To: All U.S. and Canadian Volvo Retailers
Subject: Service Action – S10101

VOLVO CAR SERVICE AND PARTS BUSINESS				
<h1>Quality Bulletin</h1>				
TITLE: Service Action S10101: AC Hose Grommet, XC40 Recharge Model Year 2021				
GROUP: 8741	CAT/NO: S10101	ISSUING DEPARTMENT: Product, Safety and Compliance	CAR MARKET: United States and Canada	
REVISIONS:			ISSUE DATE: 2021-06-10	STATUS DATE: 2021-06-10
Page 1 of 3

Title	Connector Block to Air Conditioning Compressor (AC) Line	Page	1 (4)
Action	Adjustment	Operation number:	97768-2

Adjustment

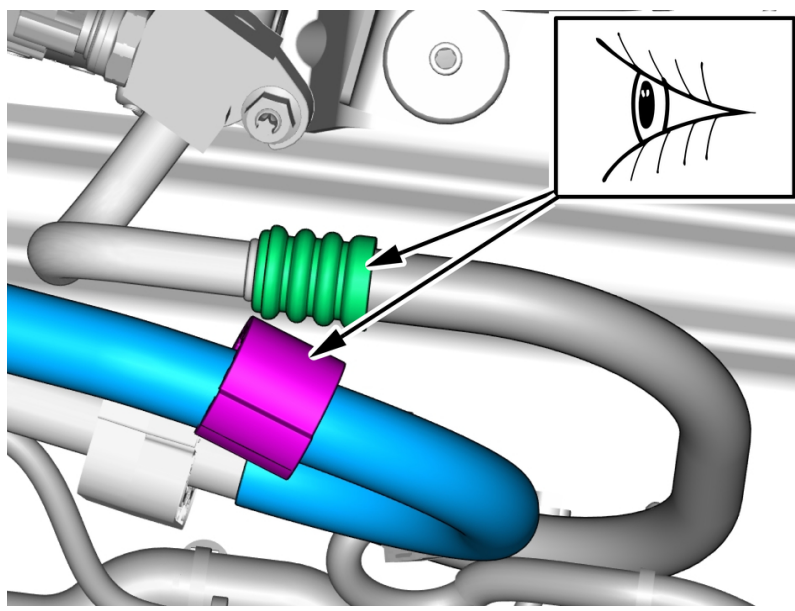
Volvo has identified that the Air Condition hose grommet (chafing protection) is incorrectly positioned.

Pull the component in direction of the arrow.

Caution! Make sure that the component is positioned correctly.

Adjust the position of the component according to image.
